NUREG-1911, Rev. 4

# **NRC Periodic Compliance Monitoring Report for U.S. Department of Energy Non-High-Level Waste Disposal Actions**

Annual Report for Calendar Year 2011

Figure 3-1: INTEC TFF monitoring-well network (from DOE-Idaho, 2011b)

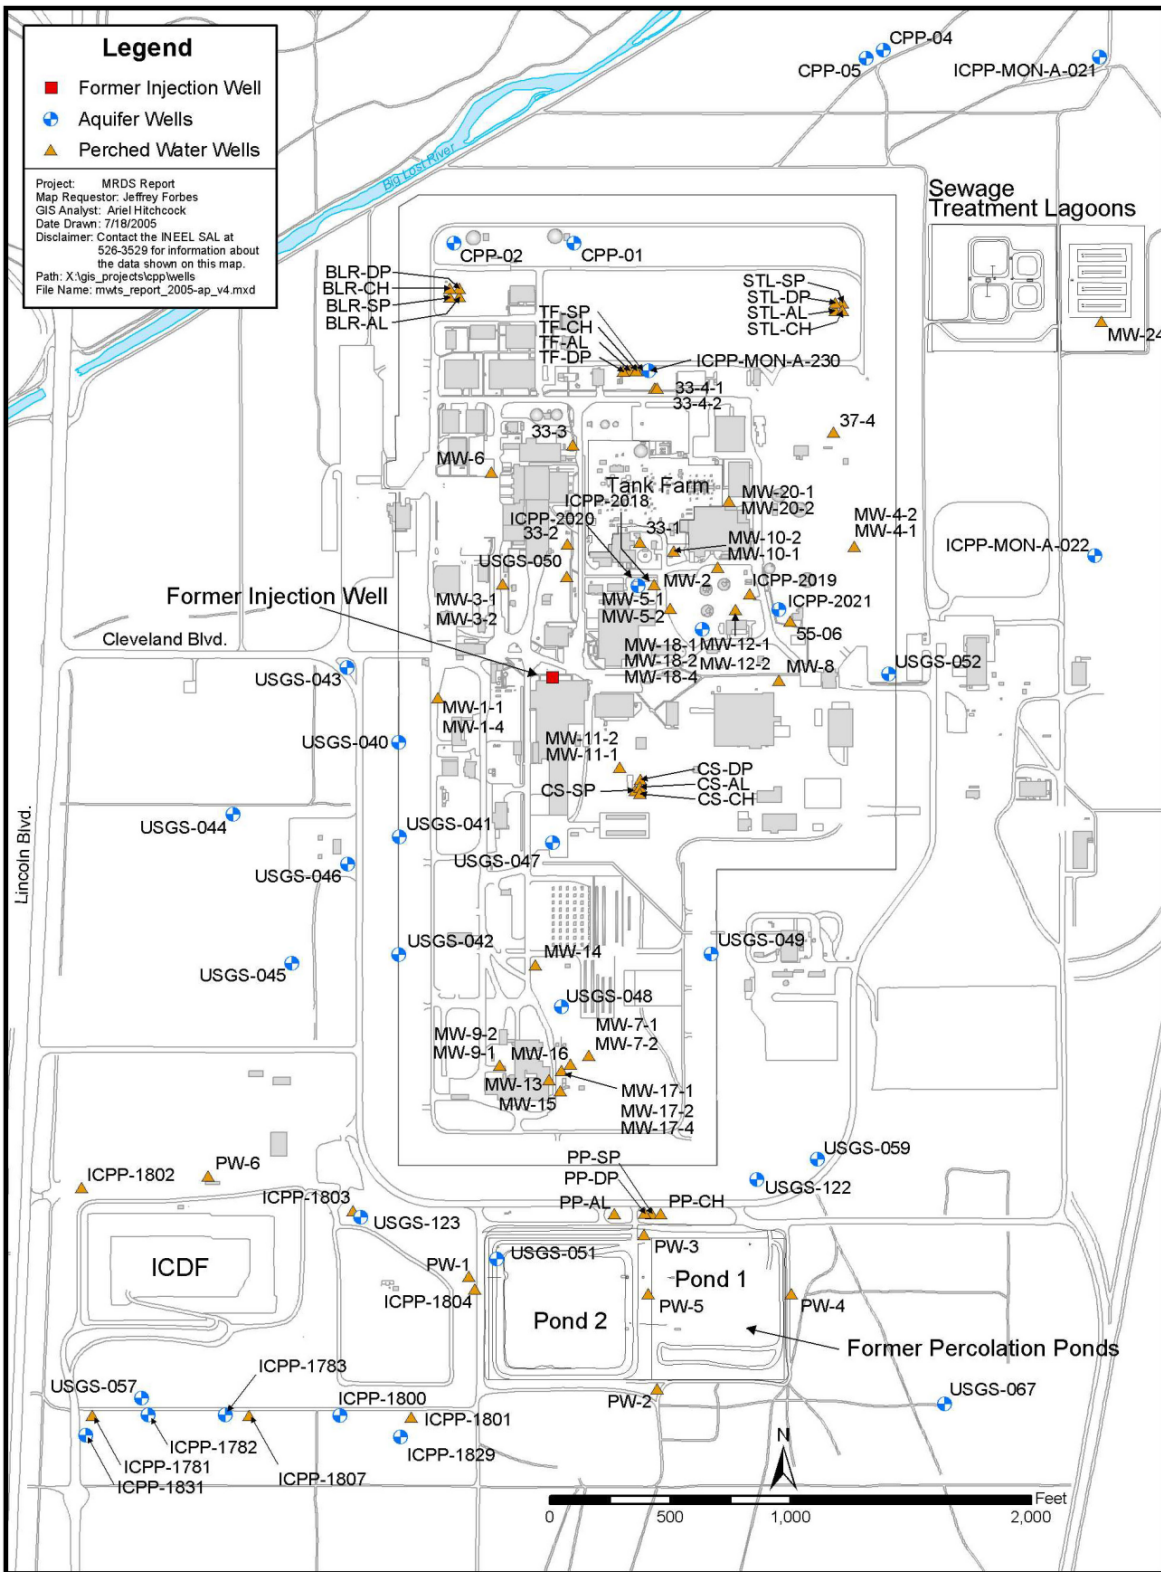
of KMA 3. During the FY 2010 reporting period DOE conducted ground water sampling at 14 SRPA wells<sup>5</sup> and five additional wells sampled as part of the Idaho CERCLA Disposal Facility monitoring program<sup>6</sup>. The operating unit monitoring plan requires sampling of 15 aquifer wells during the even years. One well, USGS-57, was not sampled in FY2010 because of an inoperable submersible pump at the time of the sampling event. Perched water samples were collected from six perched wells: 55-06, ICPP-2018, ICPP-2019, MW-2, MW-5-2, MW-10-2. Well 33-1 was not sampled because the well contained insufficient water for sampling. Well MW-10-2 only had enough water for a partial suite of analyses. Figure 3-1 shows locations of monitoring wells.

Consistent with previous data, the highest technetium-99 concentrations from the April 2010 sampling event were associated with monitoring well ICPP-MON-A-230 (71 kBq/m<sup>3</sup> or 1,930 pCi/L) located near the INTEC Tank Farm and the second-highest technetium-99 concentrations were measured at aquifer well ICPP-2021 (50 kBq/m<sup>3</sup> or 1,340 pCi/L), located southeast of the Tank Farm (see Figure 3-1). These two wells were the only wells to exceed the technetium-99 MCL<sup>7</sup> of 33 kBq/m<sup>3</sup> (900 pCi/L). All wells show stable or declining trends.

Consistent with previous data, very high strontium-90 levels (>370 kBq/m<sup>3</sup> or 10,000 pCi/L) were observed in the northern shallow perched water across INTEC. The highest strontium-90 concentrations were observed in wells southeast of the Tank Farm. The maximum strontium-90 concentration detected was 5.7 MBq/m<sup>3</sup> (154,000 pCi/L) at monitoring well ICPP-2018 (see Figure 3-1). At most well locations, strontium-90 concentrations were similar to those observed during the previous year, but are approximately half those reported in the same wells during the mid-1990s because of decay and transport. Gross beta activity was detected at nearly all perched water sampling locations with the highest gross beta level occurring at well ICPP-2018 (12 MBq/m<sup>3</sup> or 326,000 pCi/L) consistent with the strontium-90 data. Strontium-90 was detected in 13 of 14 SRPA wells with samples from seven of the wells exceeding the Sr-90 MCL of 296 Bq/m<sup>3</sup> (8 pCi/L). The highest measurement of Sr-90 in the aquifer was 918 Bq/m<sup>3</sup> (24.8 pCi/L) at well USGS-47 located down gradient of the former INTEC injection well. All wells showed similar or slightly lower strontium-90 levels compared to the previous reporting period.
